Technical Memorandum

To: Ann Foss, Minnesota Pollution Control Agency; Jess Richards, Minnesota Department of Natural Resources; Kenton Spading, U.S. Army Corps of Engineers
Prepared for: Poly Met Mining, Inc.
From: Don E. Richard, PhD, P.E.
Subject: Proposed Waste Water Treatment System (WWTS) Relocations (Version 3)
Date: April 11, 2017
c: Jennifer Saran, Christie Kearney, PolyMet

Subject: Proposed Waste Water Treatment System (WWTS) Relocations (Version 3)

MINE SITE: PROPOSED WWTS RELOCATIONS

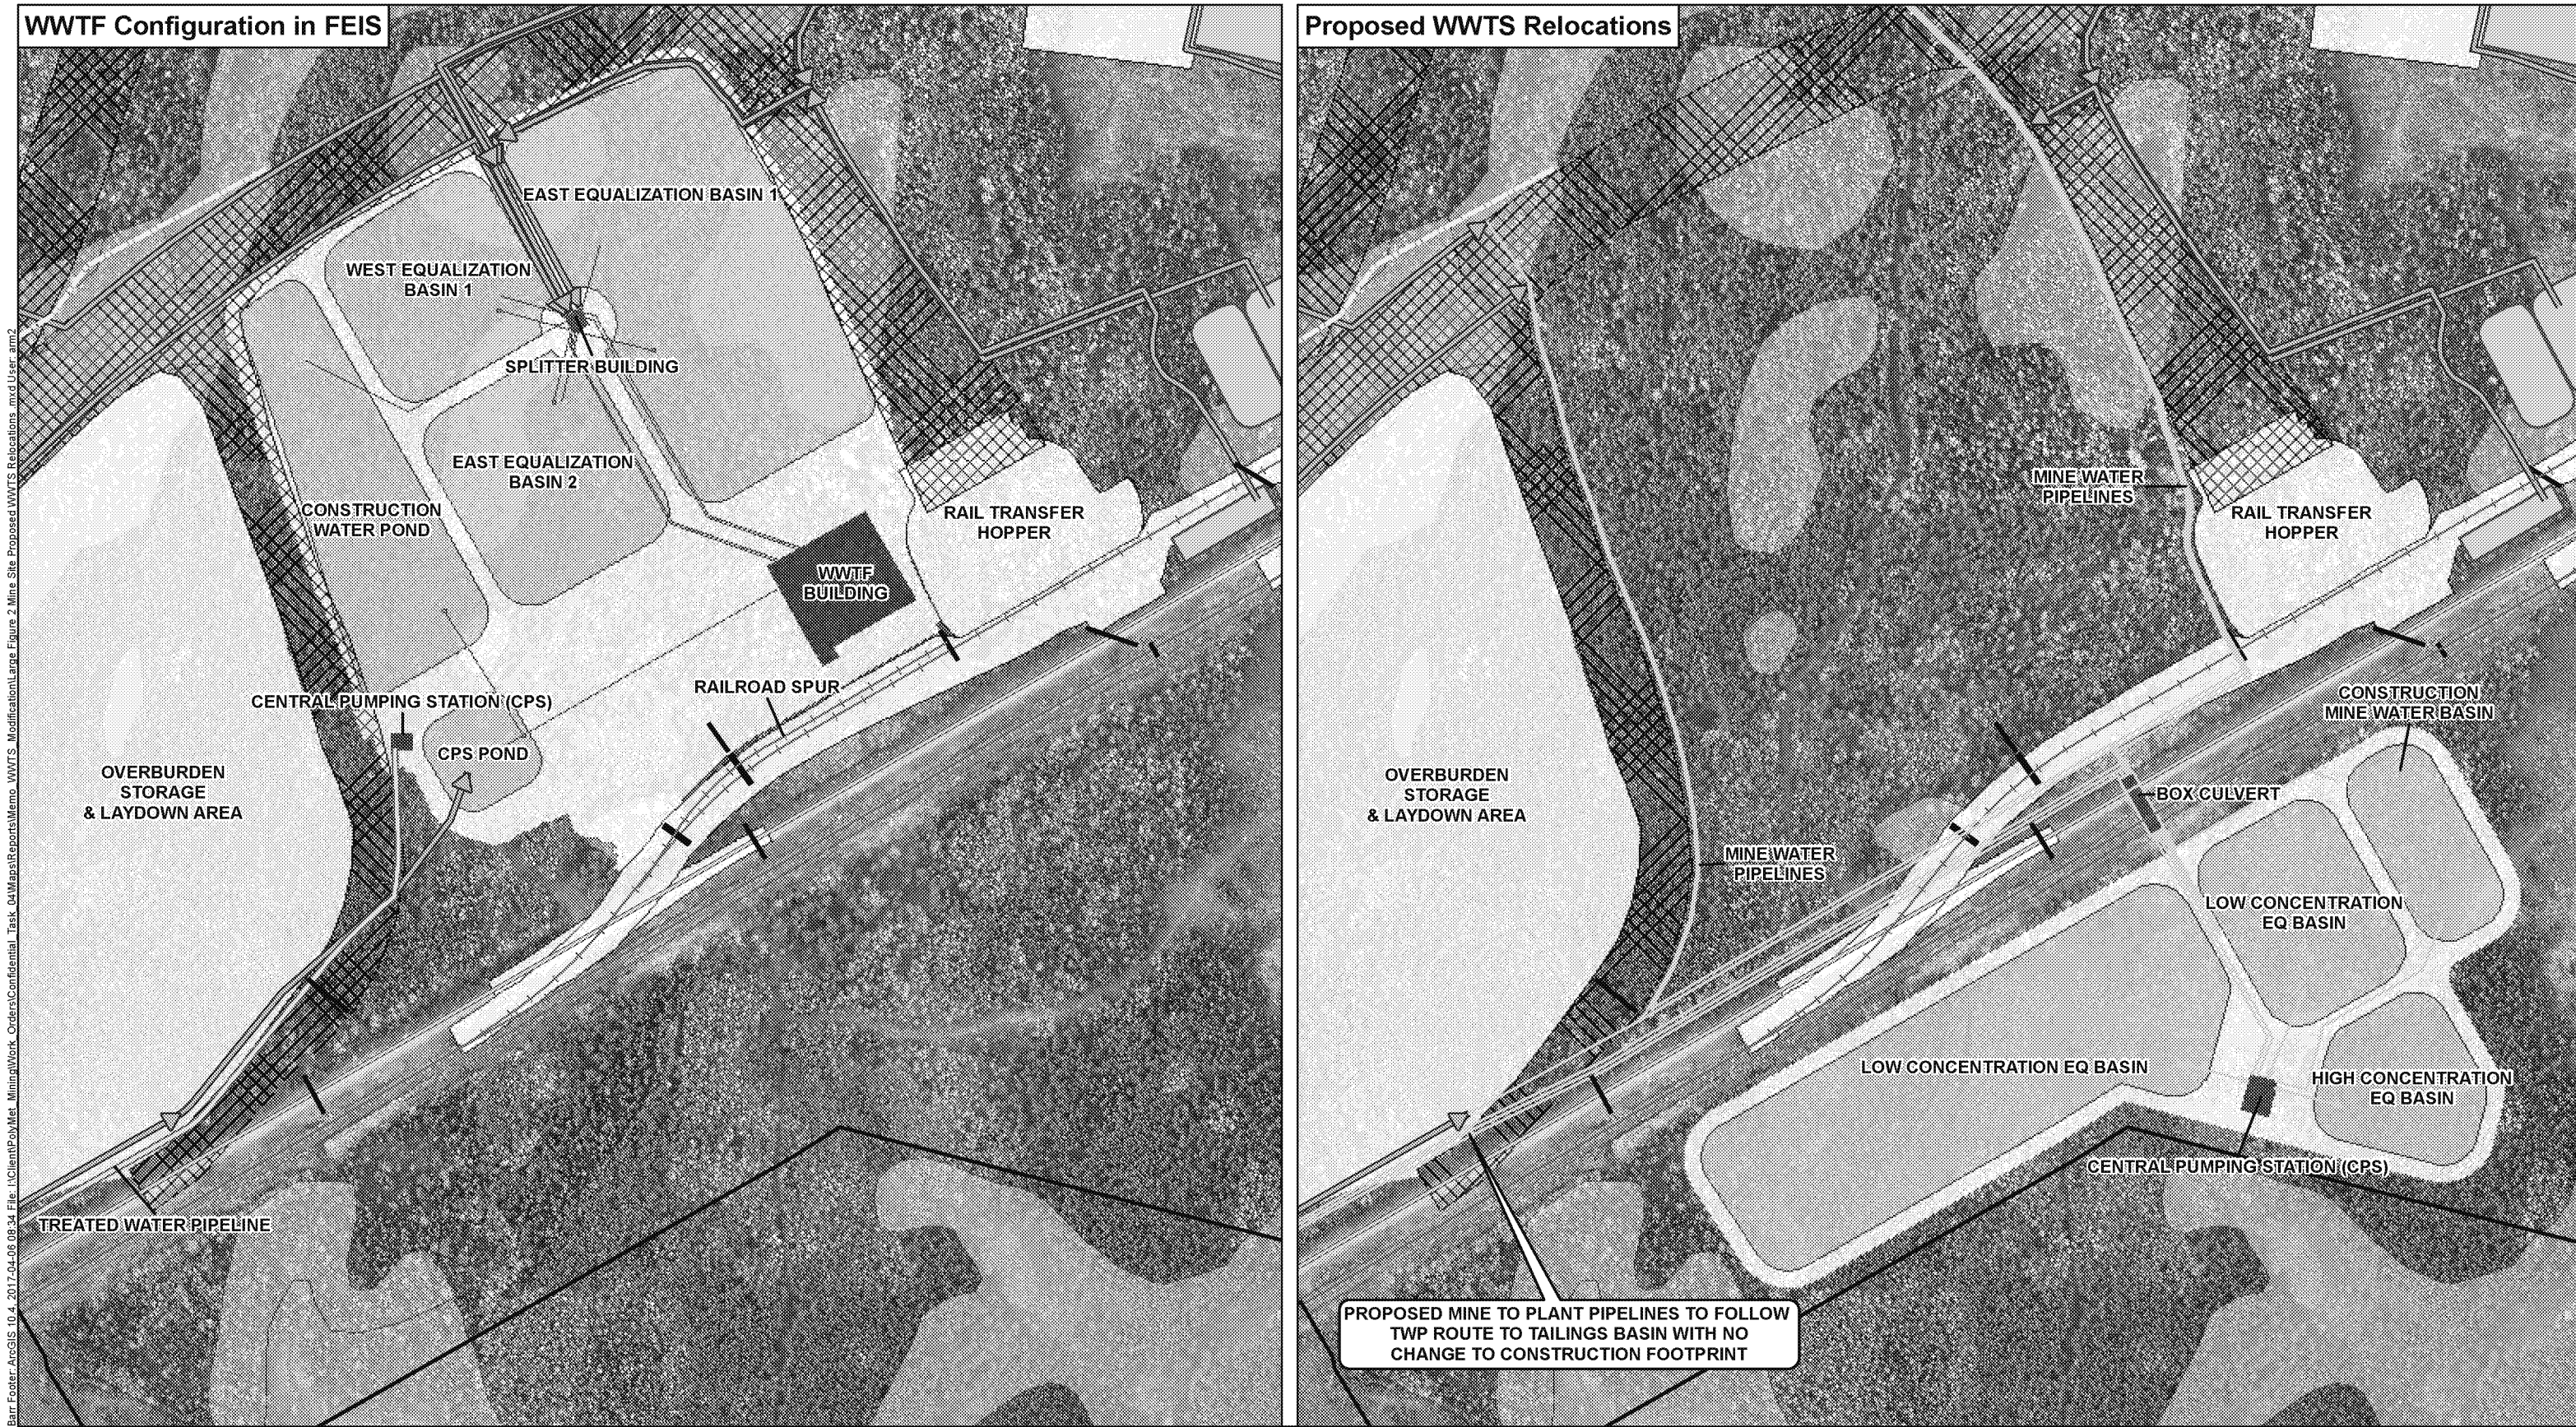
The location for the WWTS, at the location of the former WWTP, is shown on Large Figure 1. At the Mine Site, the WWTF would be eliminated and the equalization basins would be relocated to the south of Dunka Road as shown on Large Figure 2. To transport mine water to the Plant Site for treatment, the single Treated Water Pipeline would be replaced by a three pipeline system. The three Mine to Plant Pipelines would deliver three types of mine water (high concentration mine water, low concentration mine water, and construction mine water) to their respective destinations at the Plant Site (additional details below). Piping relocations necessary to accommodate these changes are shown on Large Figure 1, Large Figure 2, and Large Figure 3. These changes will not increase the proposed corridor width along the Transportation and Utility Corridor or the wetland impacts along the Transportation and Utility Corridor.

With the WWTS relocations at the Mine Site, wetland impacts would decrease by 7.9 acres, including 7.8 acres of direct impact and 0.1 acres of indirect impact (fragmentation)². Wetland impacts would be reduced by 0.3 acres in open bog (Wetland 47; direct impact³), by 0.4 acres in coniferous swamp (Wetland 48A; direct impact), and by 7.6 acres (7.5 acres of direct impact and 0.1 acre of indirect (fragment impact)) in coniferous bog (Wetlands 80, 86, 88, and 104). Based on the factors for potential indirect wetland impacts, as identified in the Wetland Data Package (Reference (3)), these wetlands would have a Rating of either 1 or 2 (one or two factors potentially indirectly impacting a wetland). The bog wetlands have a rating of 1 and the coniferous swamp has a rating of 2. Based on these ratings, no changes are planned for the Monitoring Plan for Potential Indirect Wetland Impacts (Reference (4)).

PLANT DRAWING NUMBER: LARGE FIGURE 3

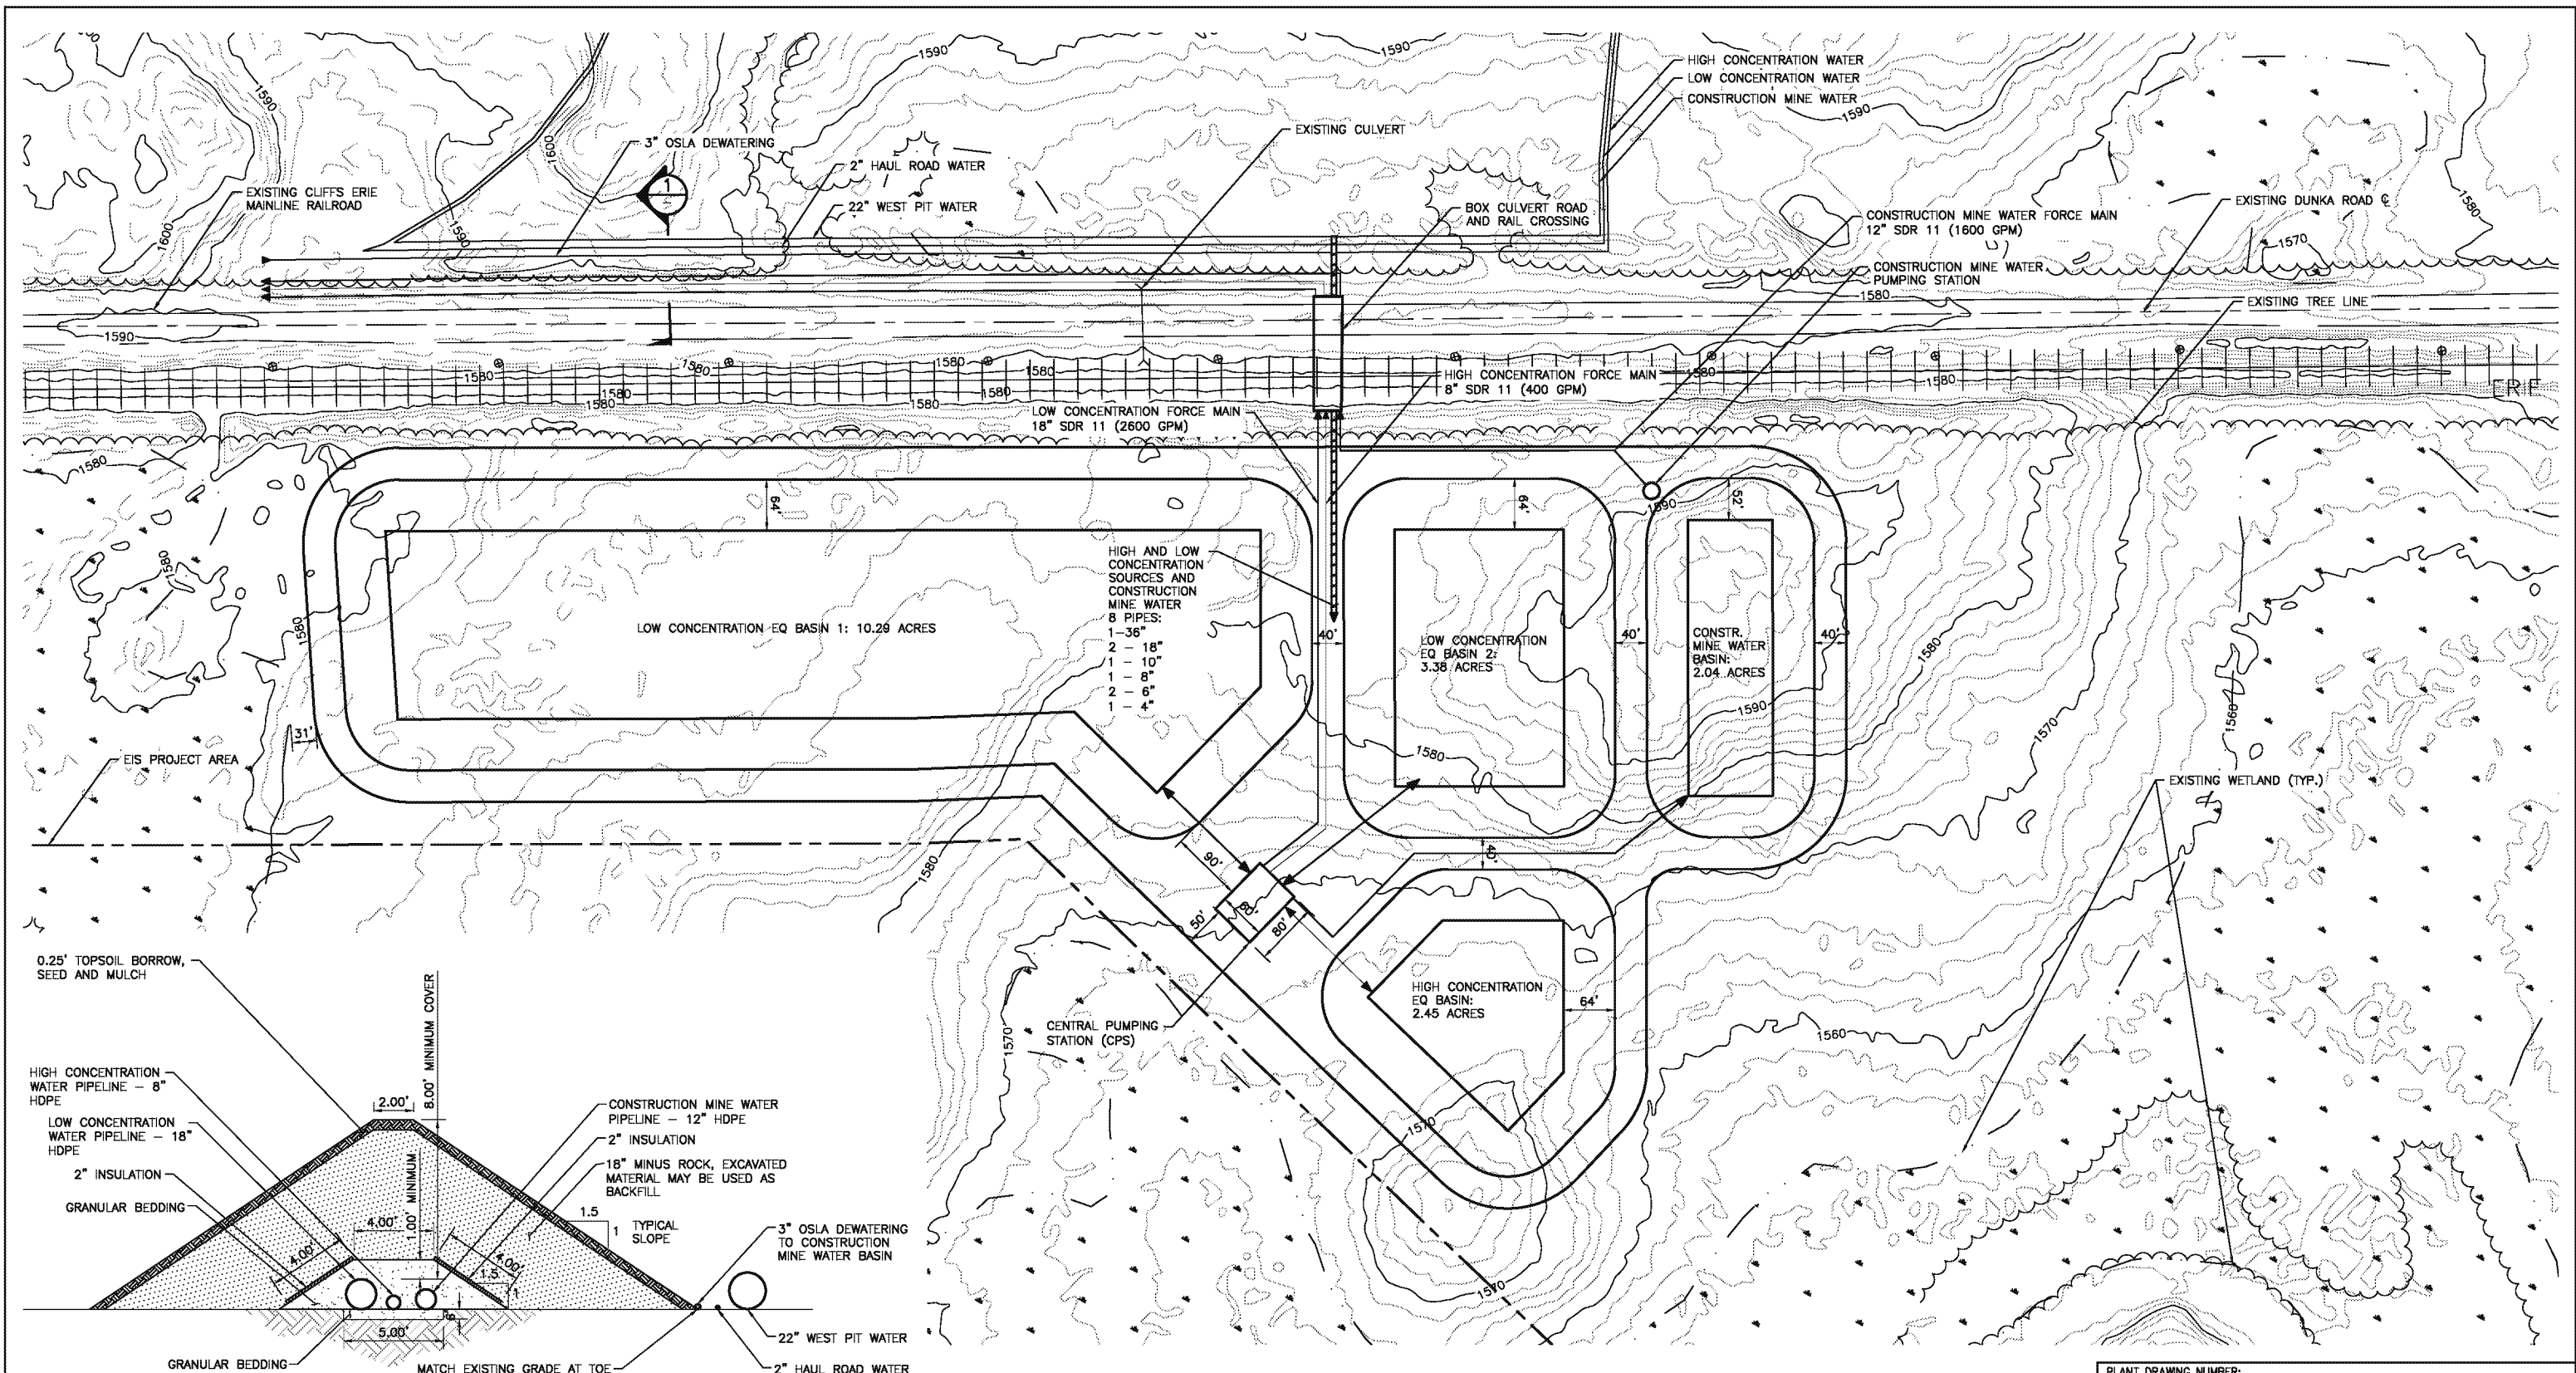
- The Treated Water Pipeline would be replaced with three separate pipelines to convey water between the Mine Site and the Plant Site within the same pipeline corridor. The two pipelines carrying mine water from the Mine Site equalization basins would be extended to the Plant Site WWTS building, and the pipeline carrying construction mine water would be routed to the FTB, consistent with what was presented in the FEIS. These pipelines would have flow meters at both ends of each pipe for leak detection. A cross-section of the proposed Mine to Plant Pipelines is included on Large Figure 3.

PLANT DRAWING NUMBER:	
COMBINED WWTs OVERALL GENERAL ARRANGEMENT Large Figure 5	
 POLY MET MINING, INC. NORTHMET PROJECT HOYT LAKES, MINNESOTA	
 BARR ENGINEERING COMPANY 4300 MARKETPOINTE DRIVE Suite 200 MINNEAPOLIS, MN 55435 Ph: 1-800-632-2277	
DWG. NO. WWTs-04	REV

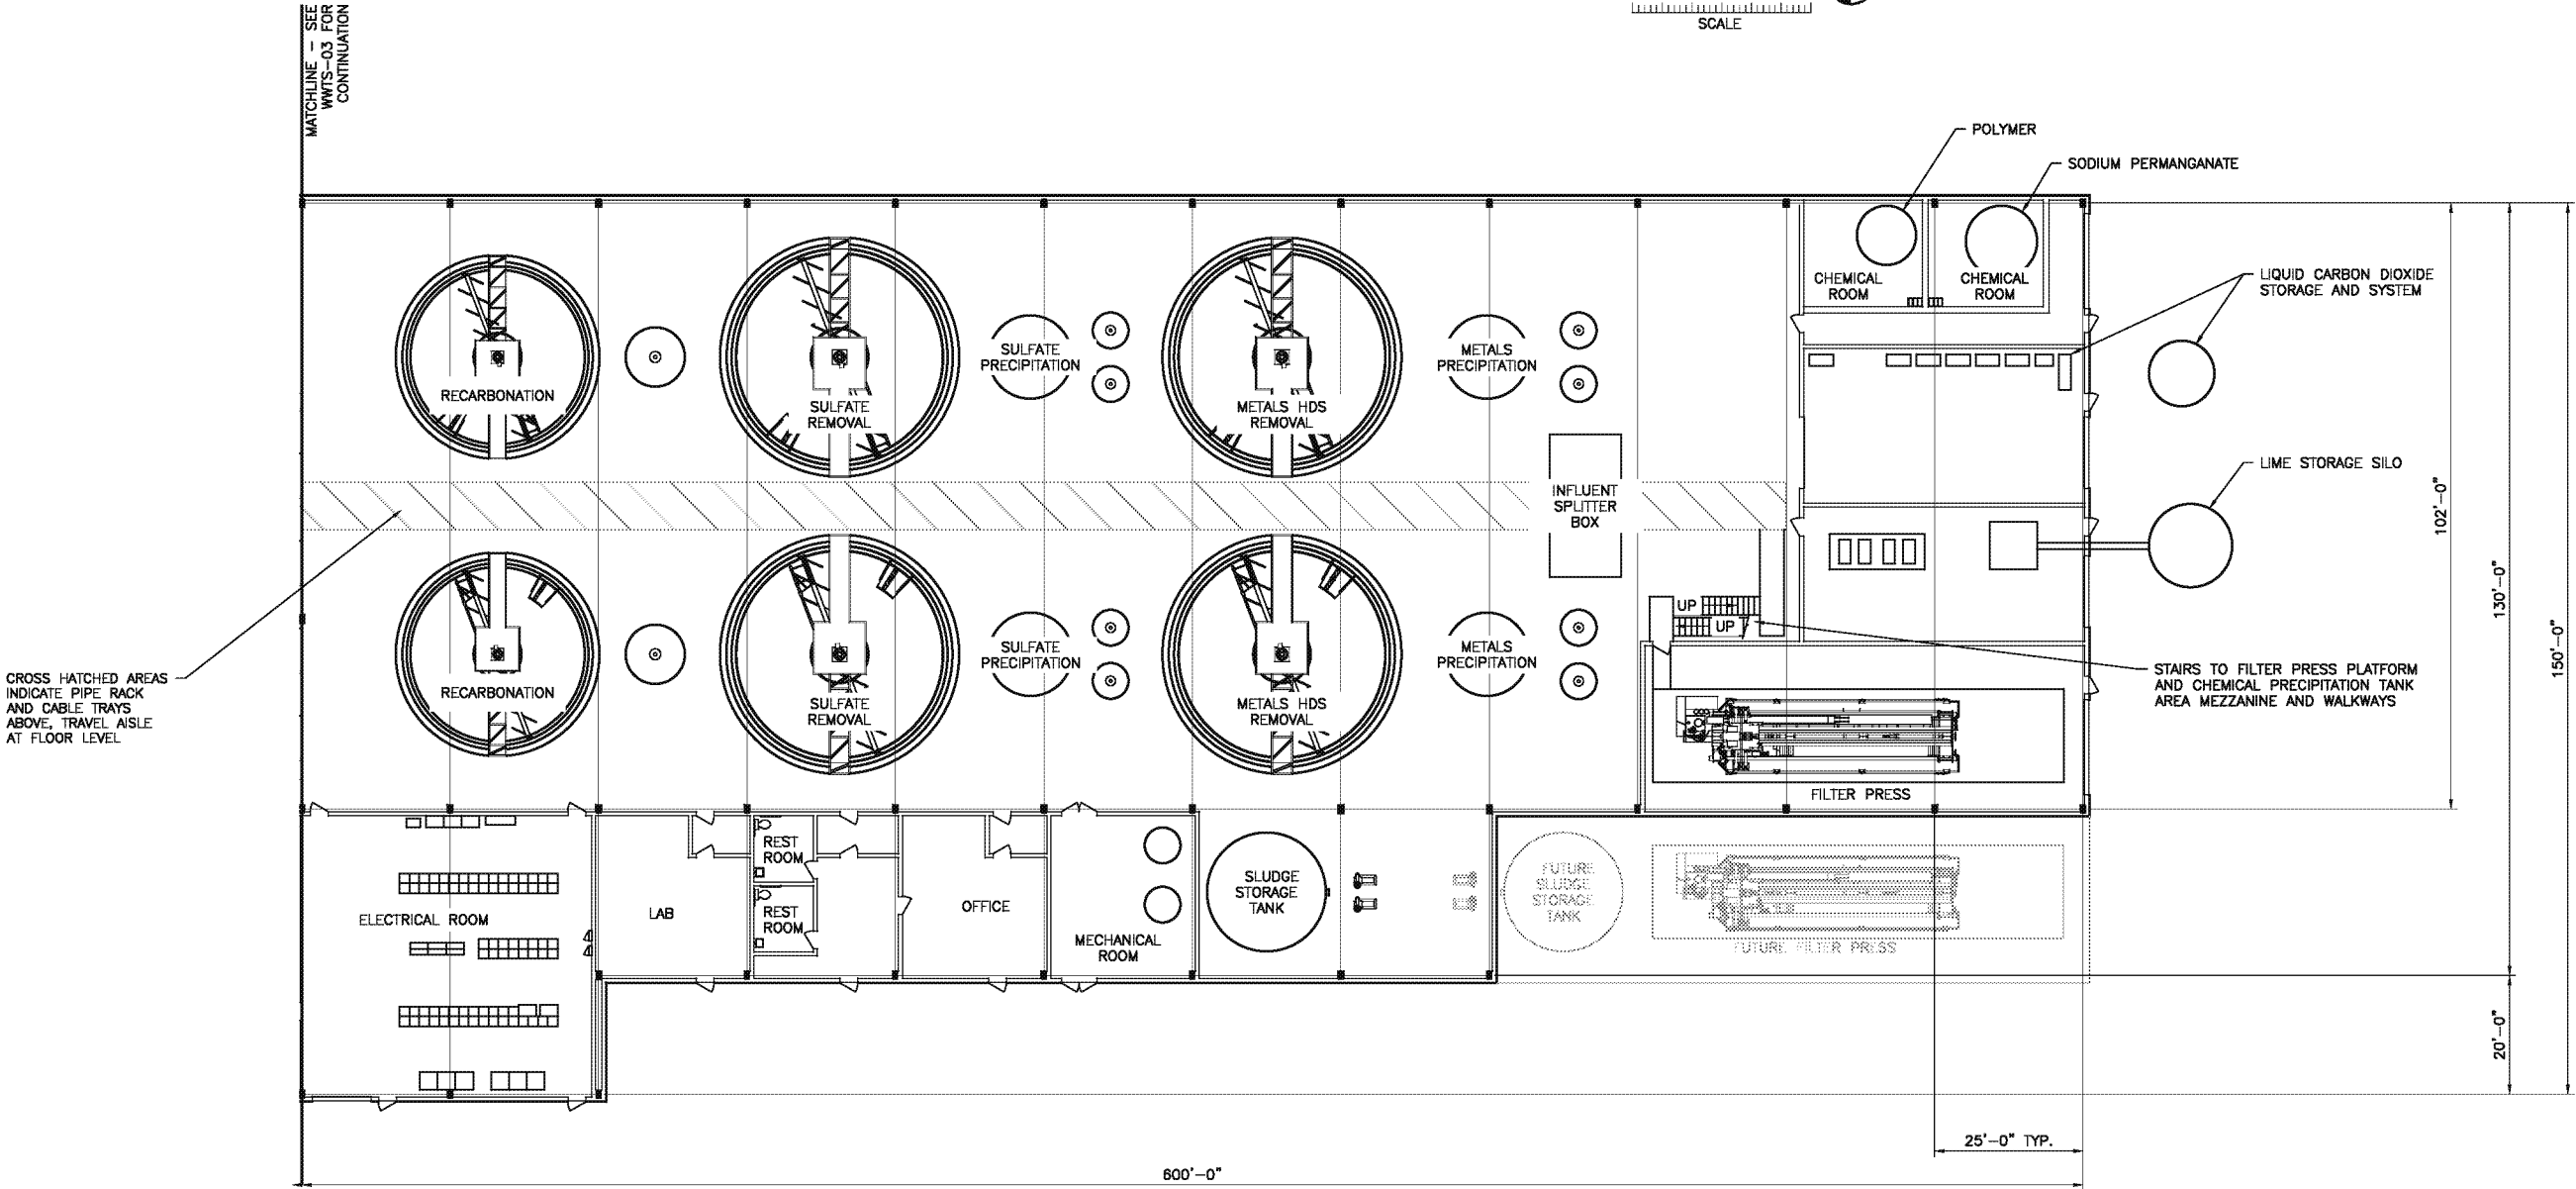
The new operation within the single WWTS building would contain all of the same treatment units and the same operating configuration as proposed in the previous two-building system. Large Figure 4 and Large Figure 5 show the general layout for the combined WWTS building, and Large Figure 6 shows the process flow diagram for the WWTS. The primary membrane operations within the single WWTS building would remain independent for the treatment of mine water and the treatment of FTB seepage capture systems water, as was the case with the two-building system. Treated mine water would continue to be routed to the FTB Pond for further removal of mercury. Treated FTB seepage would be discharged to the environment in the same quantity and quality and from the same locations. The secondary membrane operations would treat the same volume of water, and the secondary membrane concentrate would continue to be routed to the chemical precipitation treatment train.
